UNITED STATES
DEPARTMENT OF THE INTERIOR
BUREAU OF LAND MANAGEMENT

FORM APPROVED
OMB NO. 1004-0135
Expires: July 31, 2010**SUNDRY NOTICES AND REPORTS ON WELLS**
*Do not use this form for proposals to drill or to re-enter an abandoned well. Use form 3160-3 (APD) for such proposals.*5. Lease Serial No.
NMNM0467934

Cimarex Energy Co. of Colorado respectfully requests approval to plug back from the Cedar Lake Morrow pool and recompleate in the Abo according to the attached procedure.

FULL TANK 33 FEDERAL #1

Cimarex Energy Co. of Colorado
Full Tank 33 Fed Com No. 001
UL B Sec 33 T17S R30E
API 30-015-34525

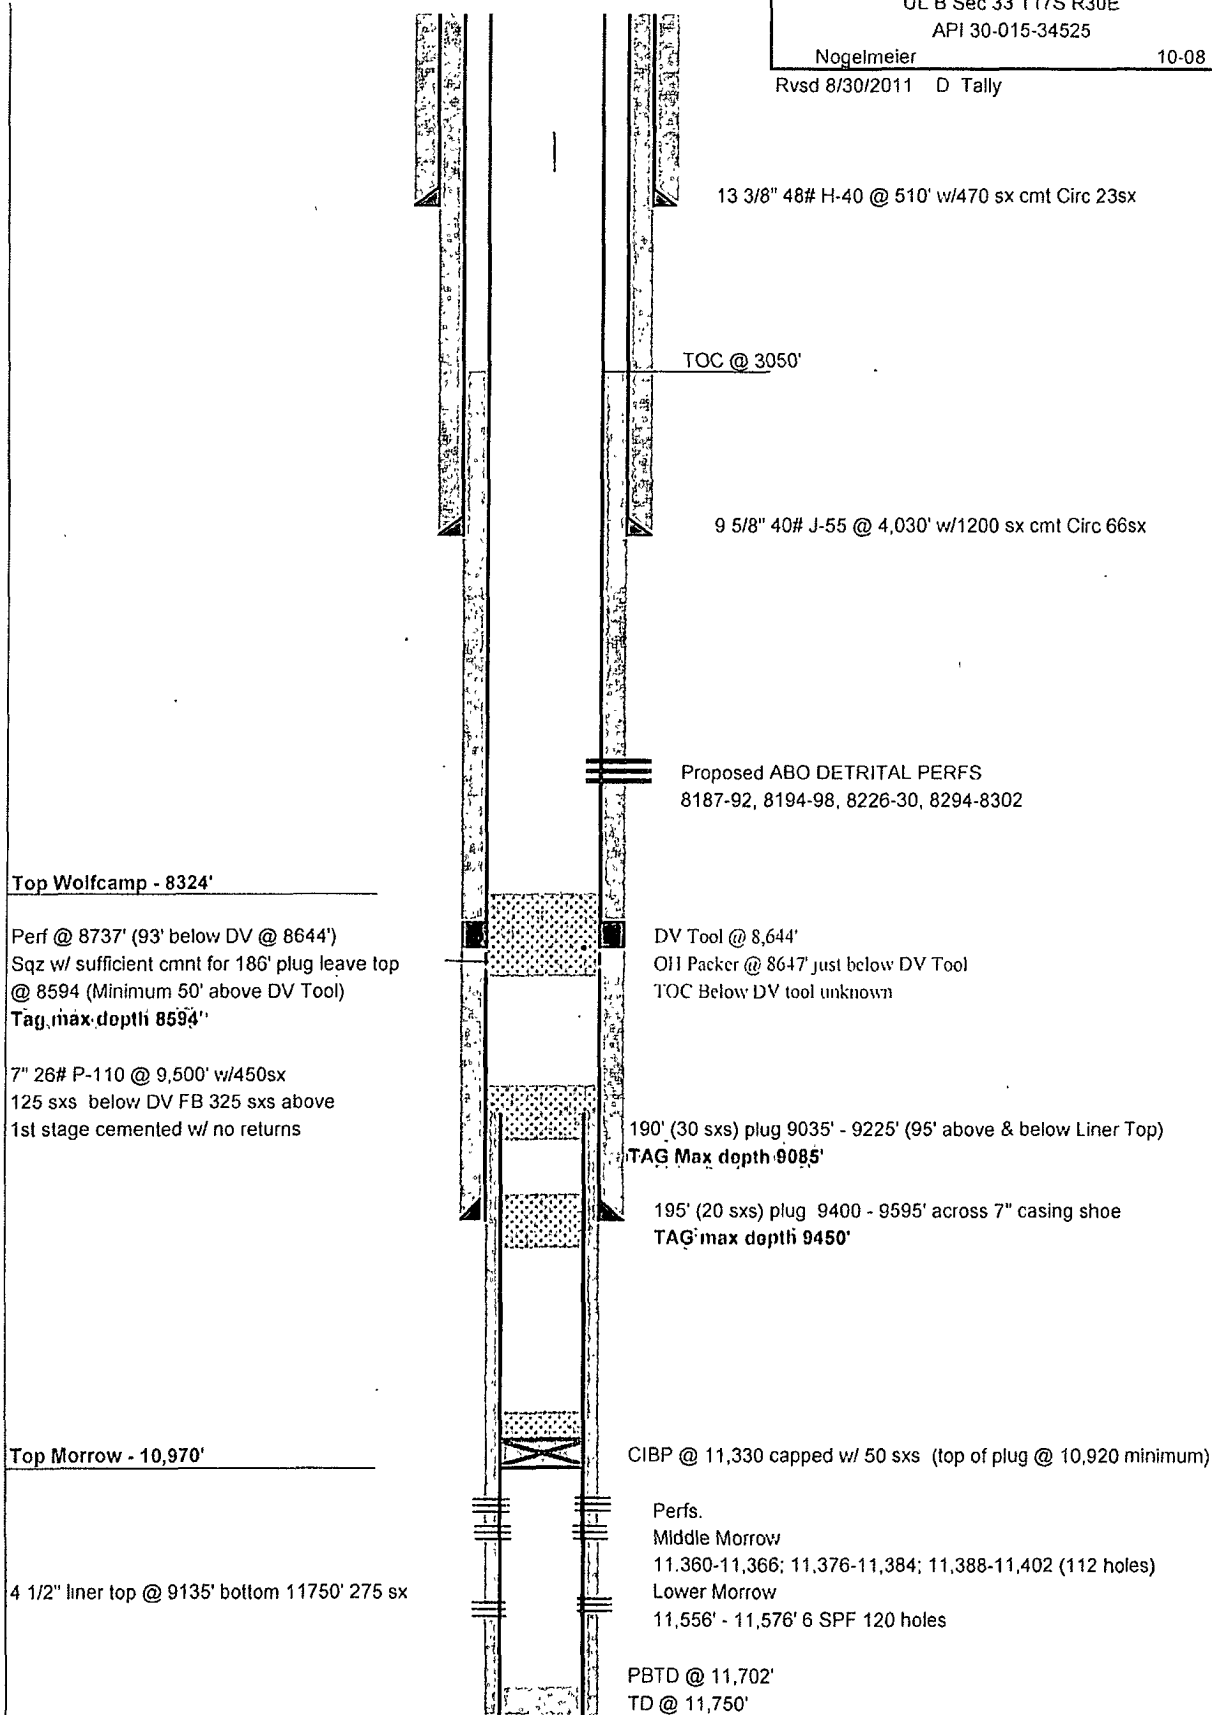
1. **Contact BLM 575-361-2822 a minimum of 24 hours prior to performing operations.**
2. **Set CIBP 50-100 feet above the top perforation.**
3. Surface disturbance beyond the originally approved pad must have prior approval.

8. Operator to verify formation tops on completion report, previous completion report appears to have errors with the formation tops.
